26 July 2018

**SSDA 7745 - SECTION 4.55(1A) MODIFICATION APPLICATION
NSW RUGBY LEAGUE CENTRE OF EXCELLENCE – SITE 18, DAWN FRASER AVENUE, SYDNEY OLYMPIC
PARK**

Figure 2 Proposed layout of Ground Level and inclusion of a store room

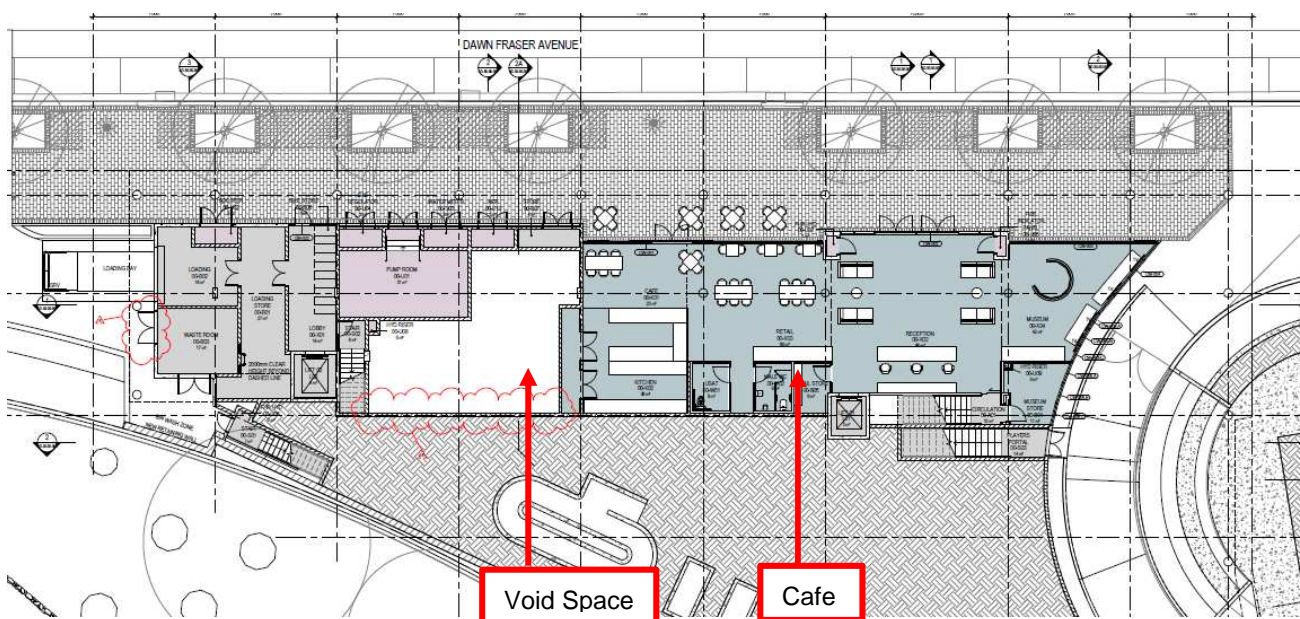
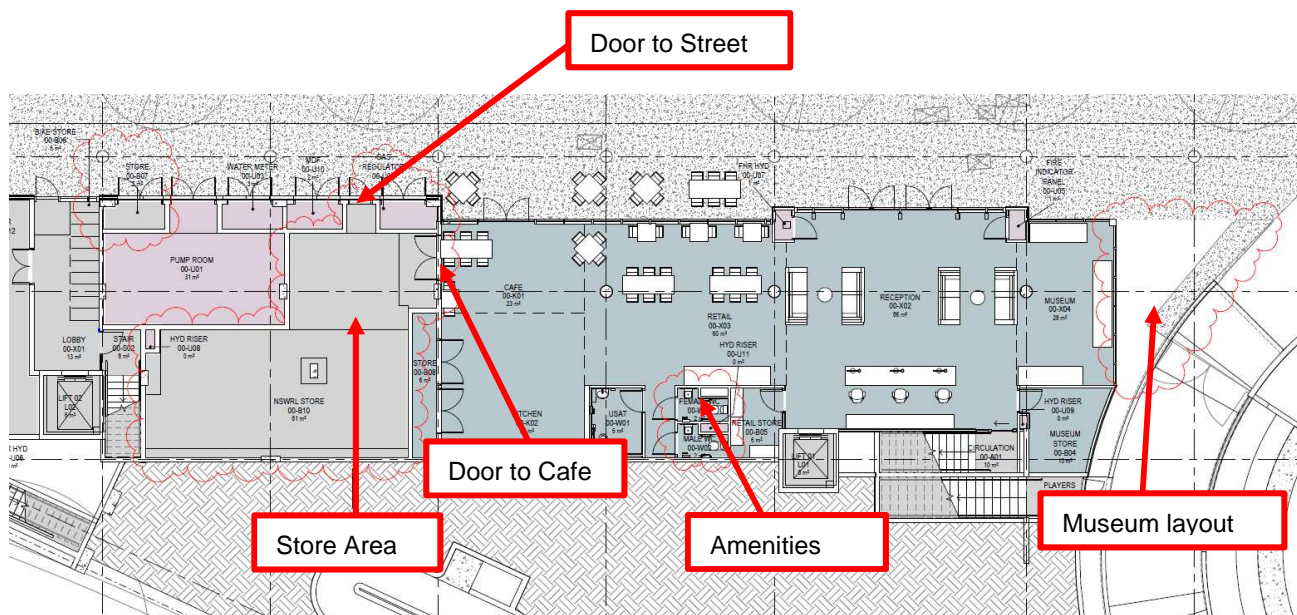
Level	Modification Description	Reason for Change
Ground	Conversion of the existing void space at Ground Level to a store room	The requirement to utilise the existing void space is the result of design development and the need for an additional storage area to be provided within the development.
	Provision of a double door between the store room and the café/street to allow access	The installation of the two sets of doors is required to provide both internal and external access to the store room.
	Provision of a door to the store room leading from Dawn Fraser Ave	
	Relocation of a gas regulator room and store room	Design Development
	Changes to amenities to provide a female toilet	Design Development
	Modification to the reduce the layout and extent of the Museum	Design Development
Roof	Change to a portion of roof materials	The western portion of the roof is proposed to change from tin to concrete to improve durability and future expansion opportunities. The concrete framing at the eastern portion of the roof is proposed to change from concrete to lightweight (tin) as a result of design development.

The modification will introduce a store room on the Ground Floor and will make a number of other minor design changes that will increase the GFA of the development.

Figure 4 Proposed layout of the Roof Level

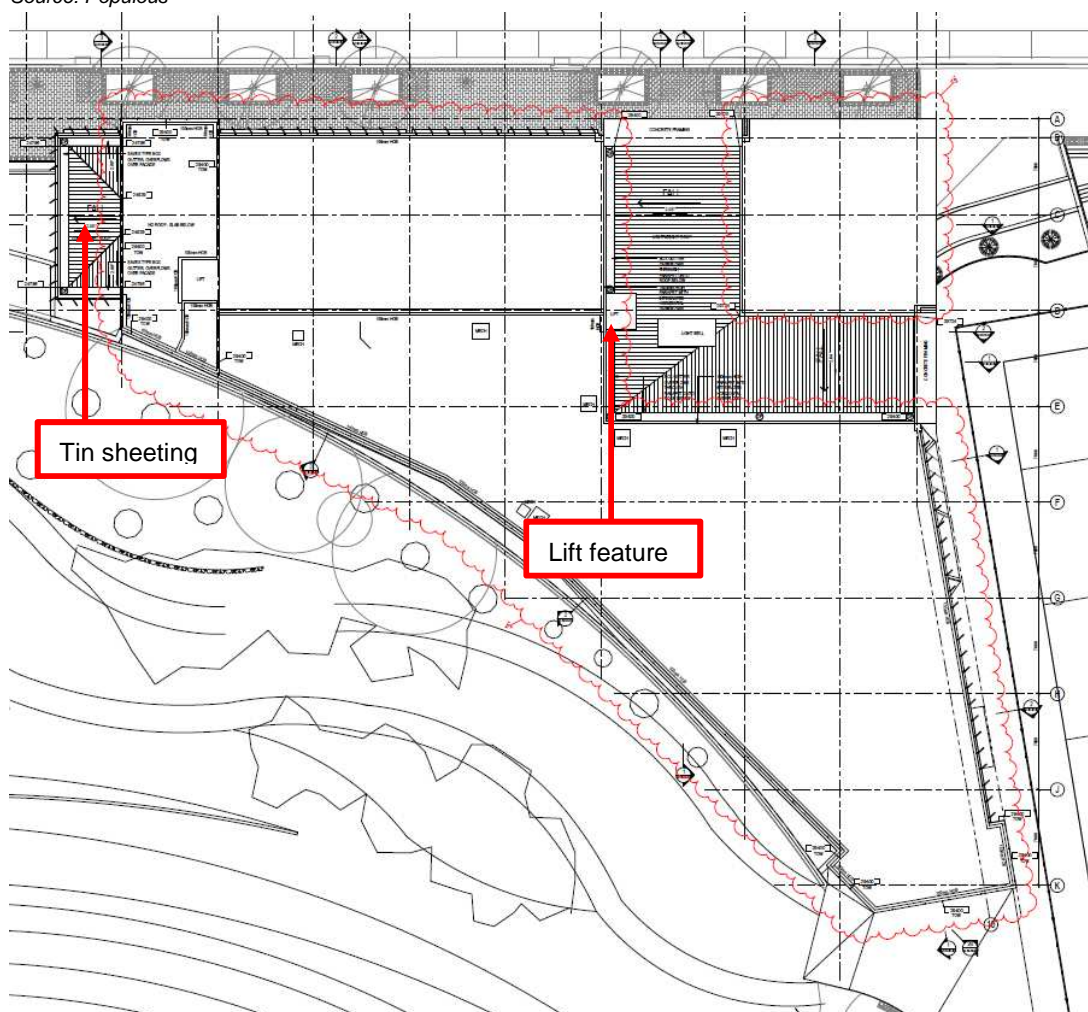
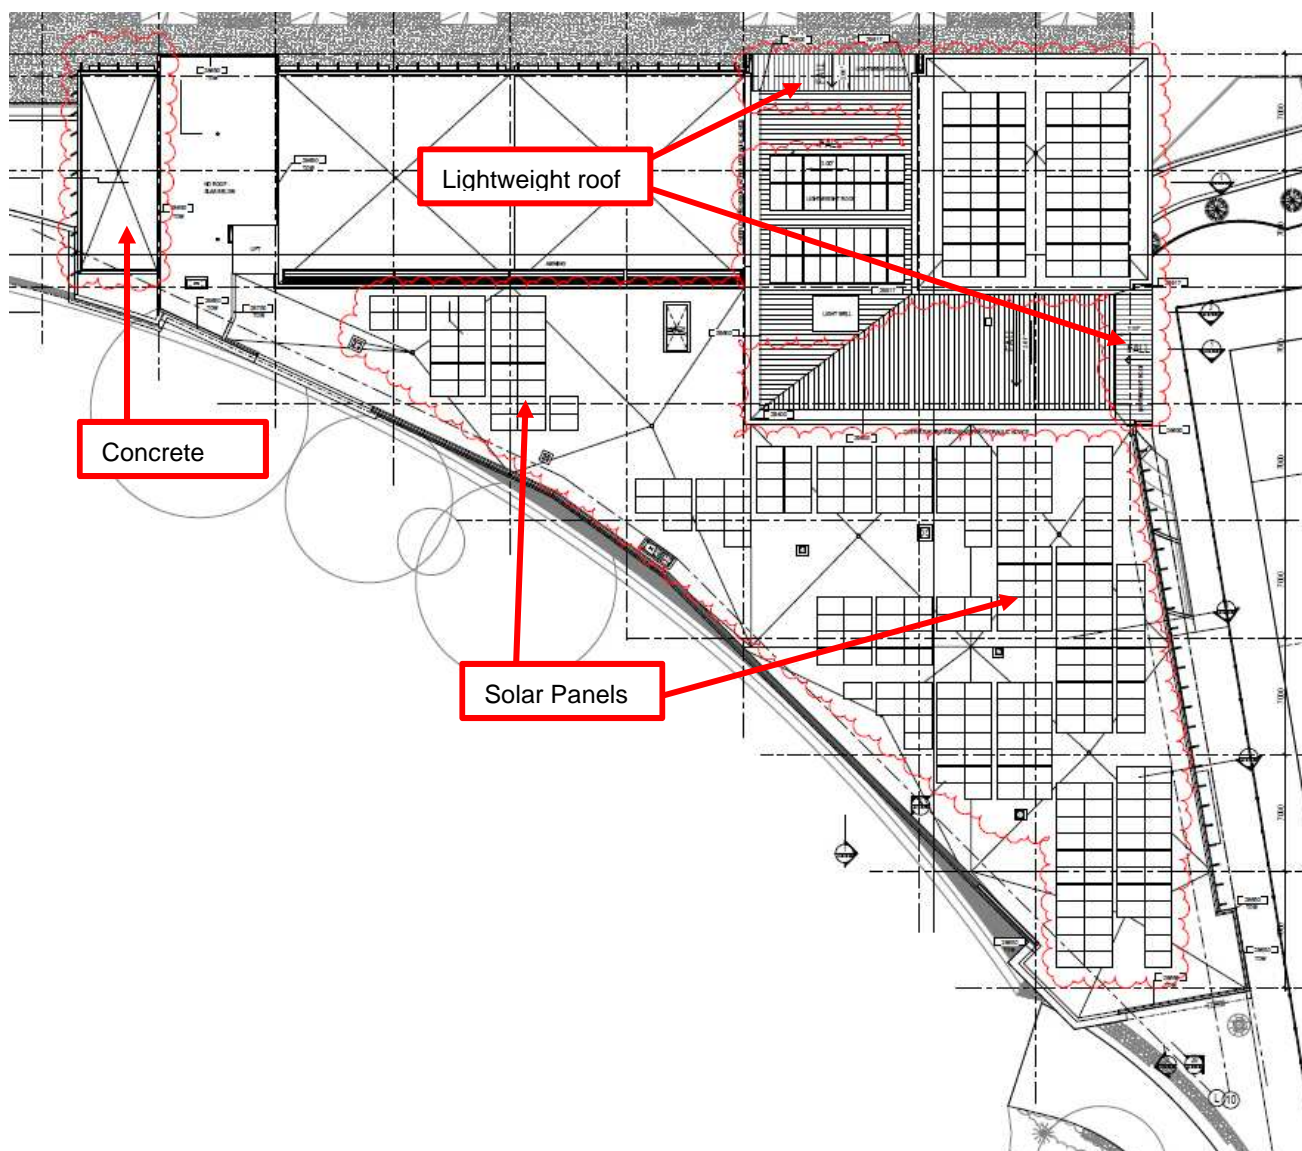
Amend a lift overrun	The lift feature is proposed to be reduced in height as the lift was able to be tucked beneath the roof sheeting.
	Inclusion of solar panels on the roof	The inclusion of solar roof panels on the Roof Level will improve the environmental performance of the building.

The introduction of solar panels on the roof will result in a minor increase in the building height relative to the height of the solar panels.

The proposed solar panels are 150mm in height. Accordingly, the proposed modification will increase the building height by 150mm from 14.44m to 15.94m. The increased height is minor, and the building remains well below the 26m permissible height for the site.

The solar panels are set back a minimum 300mm from the roof edge. As the panels sit flush against the roof, being 150mm in height, the setback will ensure that the panels are not visible from the public domain. Equally, the setback will ensure the panels do not create any overshadowing impacts.
